17 December 2021

Vaucluse West Residents Association's Submission on the Draft Cross Street Planning and Urban Design Strategy.

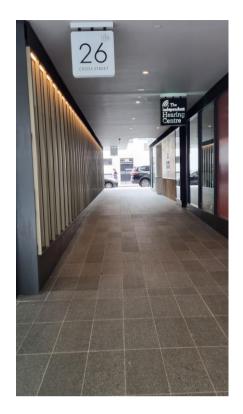
Given the unfortunate approval of the 19 - 27 Cross Street DA, which the Council chose not to appeal, the development of a discrete planning strategy just for Cross Street should have been a catalyst for the heritage or character listings of the four character-rich buildings across the street: 2C Cross Street, 4 Cross Street, 6 Cross Street and 8 Cross Street (see image below).

The ambience of this part of Cross Street is also enhanced by a magnificent Ficus tree. Protection of this part of the existing streetscape will ensure that the tree is not damaged by excavation and that its generous green canopy is not overshadowed by tall buildings.
